BROWNS FERRY NUCLEAR PLANT (BFN) – UNITS 1, 2, AND 3 – TECHNICAL SPECIFICATIONS (TS) CHANGES TS-418 AND TS-431 – EXTENDED POWER UPRATE (EPU) – RESPONSE TO ROUND 23 REQUEST FOR ADDITIONAL INFORMATION (RAI) REGARDING STEAM DRYER SIGNAL PROCESSING (TAC NOS. MD5262, MD5263, AND MD5264)

**TENNESSEE VALLEY AUTHORITY
BROWNS FERRY NUCLEAR PLANT (BFN)
UNITS 1, 2, AND 3**

**TECHNICAL SPECIFICATIONS (TS) CHANGES TS-431 AND TS-418
EXTENDED POWER UPRATE (EPU)**

**RESPONSE TO ROUND 23 REQUEST FOR ADDITIONAL INFORMATION (RAI)
REGARDING STEAM DRYER SIGNAL PROCESSING**

Figure EMCB.203-1.10c: Cross spectra (top) and coherence (bottom) of EIC removed data for BFN1 main steam line C, for CLTP conditions (black) and LF conditions (blue).

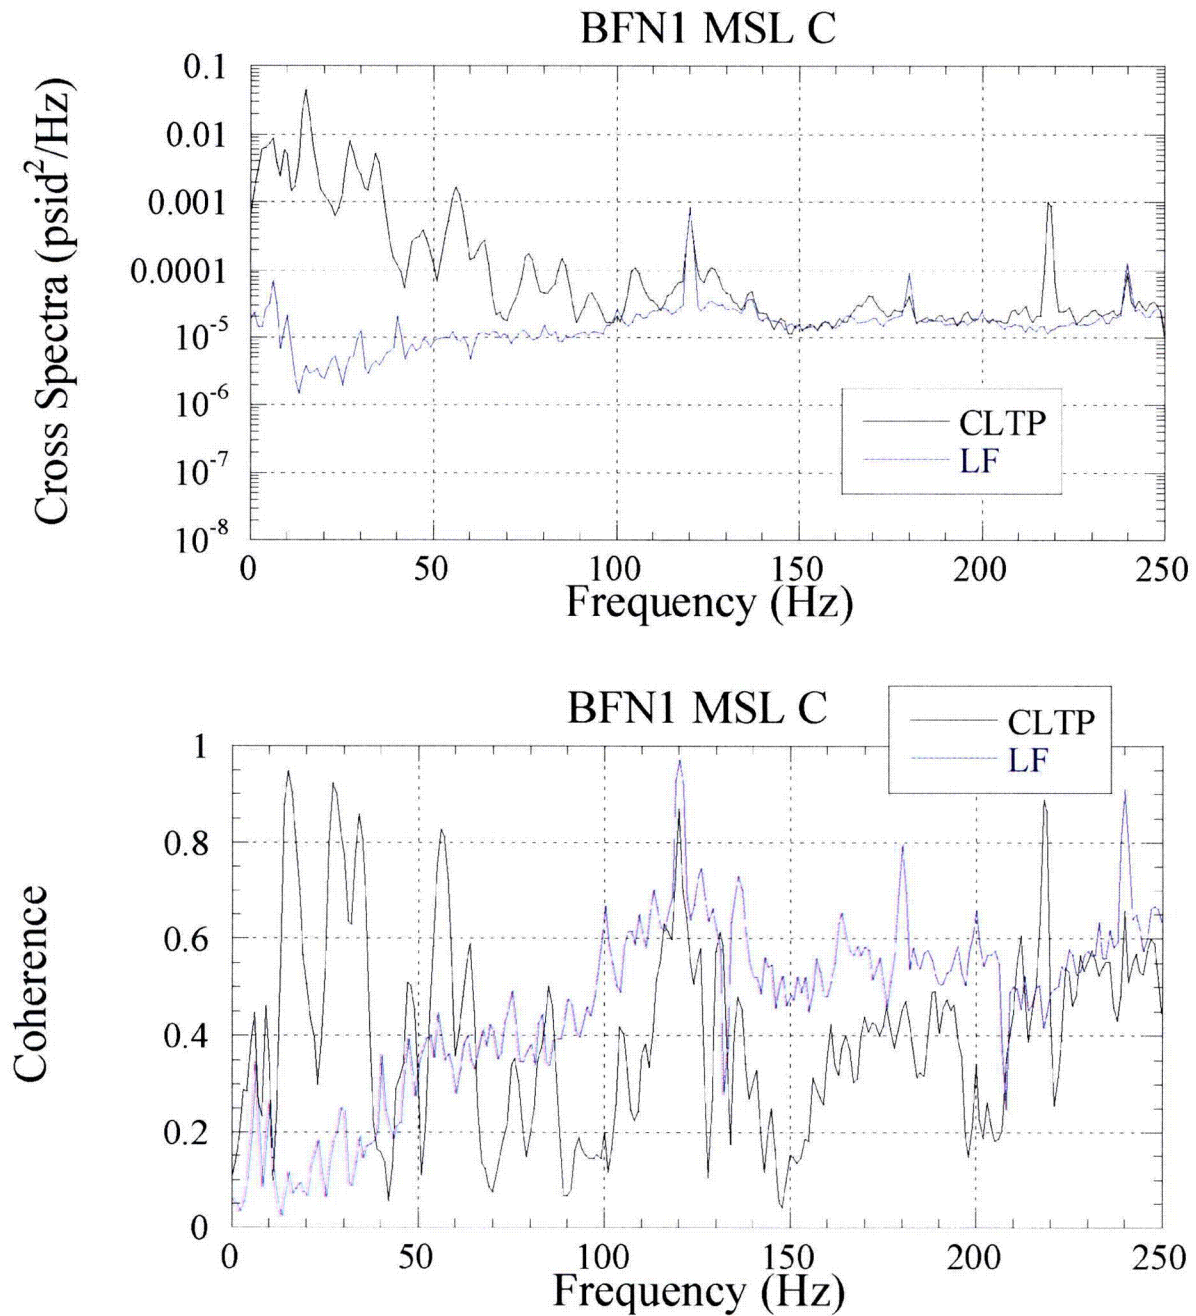
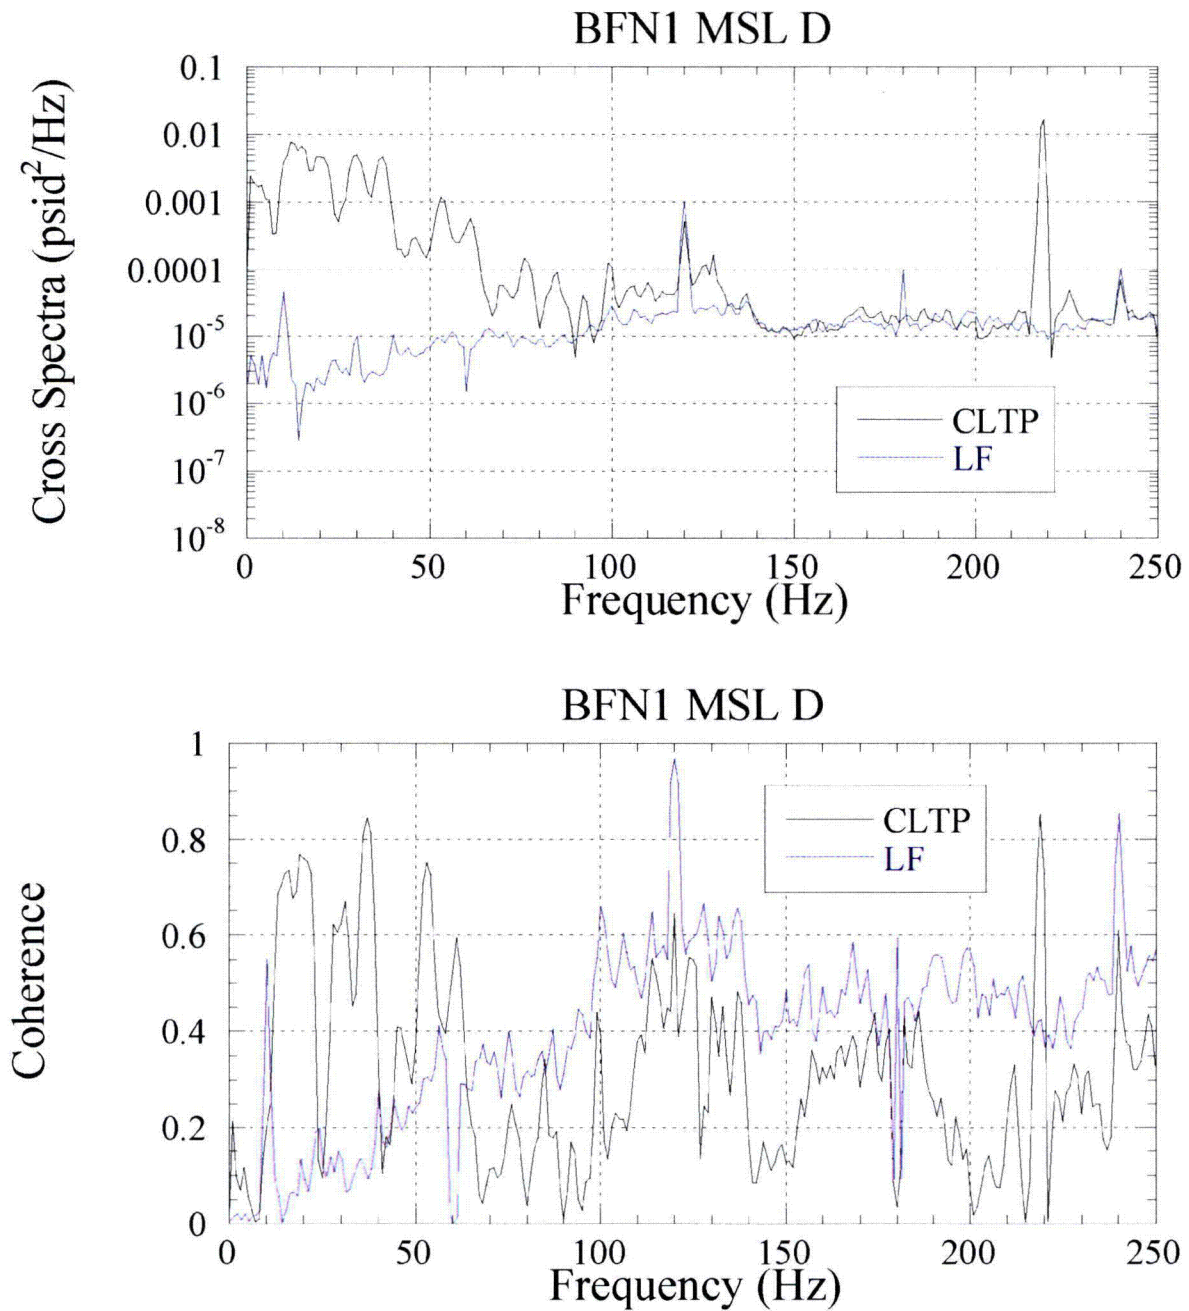
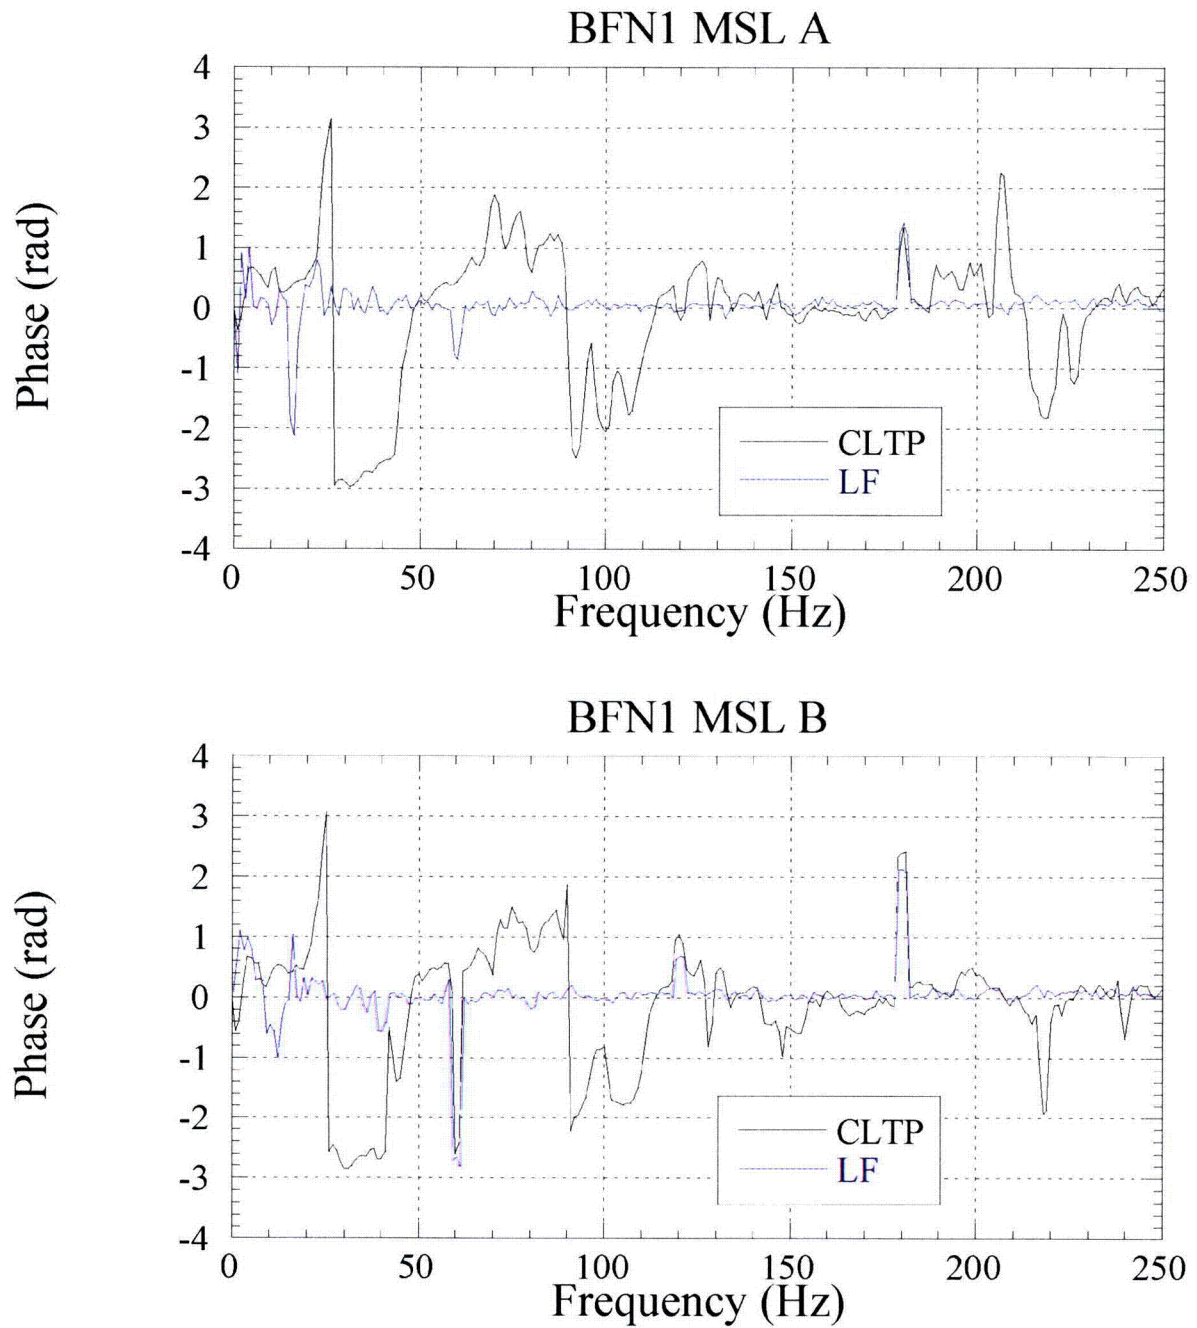
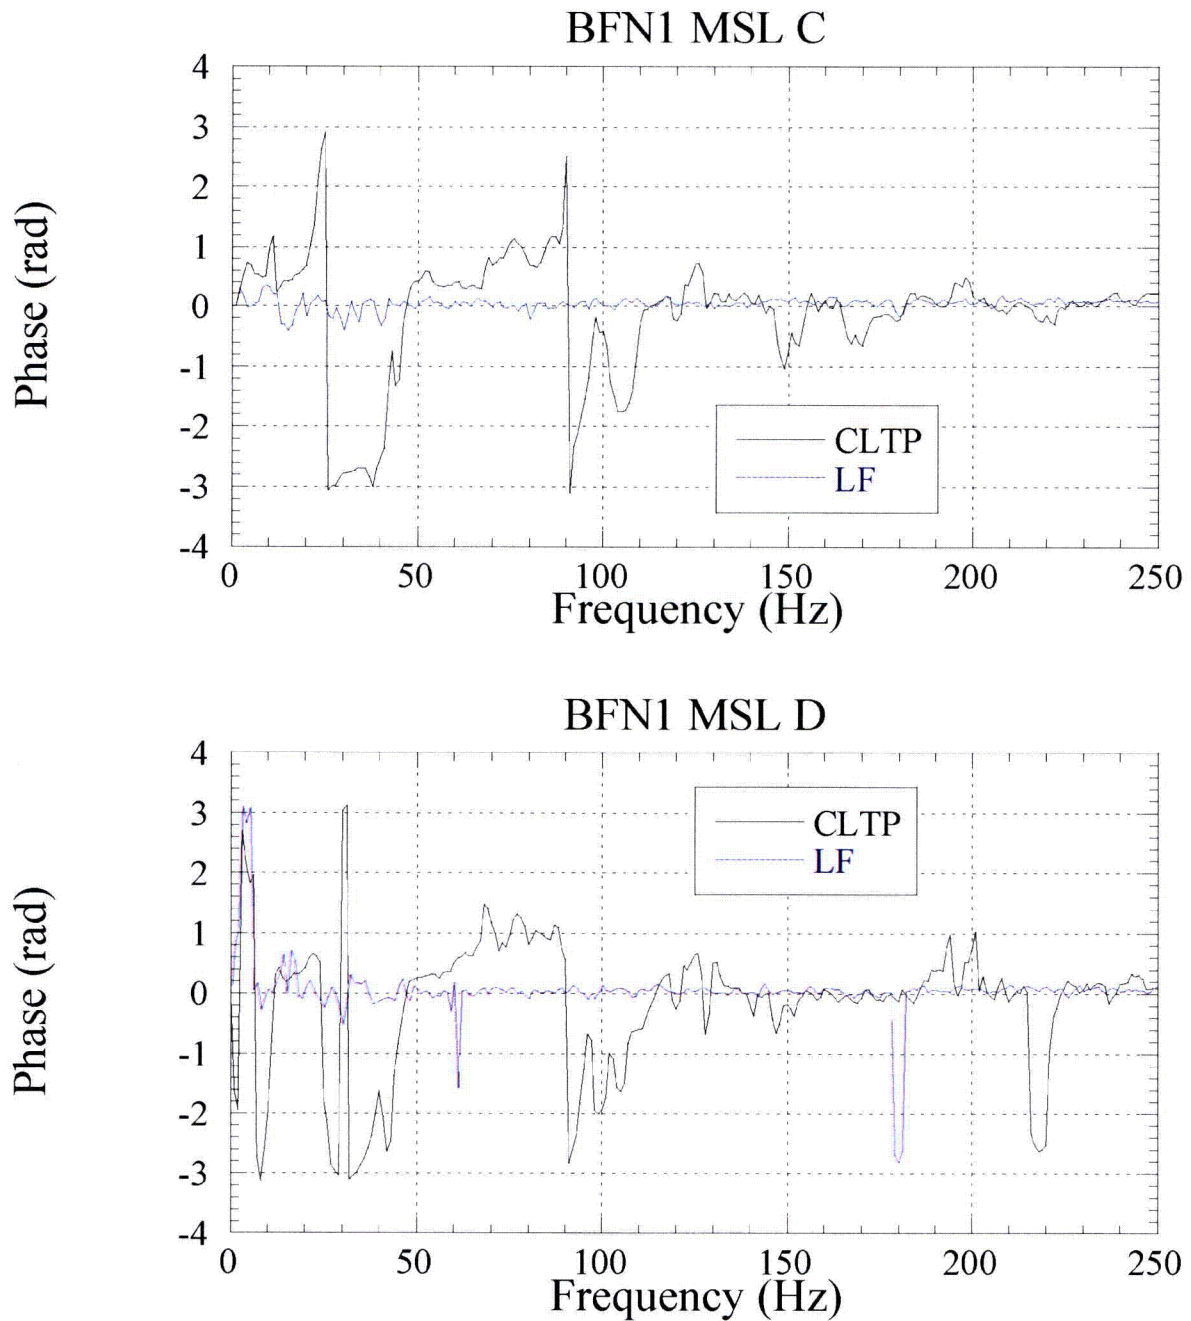
In response to EMCB.200/157., TVA presents detailed discussion of signal conditioning in six steps. Provide plots of strain gage signals (autospectra, cross spectra, coherence, and phase) and computed [[]] throughout the procedure described in their RAI response (prior to step 1, after step 1, after step 2, after step 4 and after step 6), for current license thermal power (CLTP) and Low Flow (LF) signals, for Units 1 and 2.

After Step 1: remove EIC
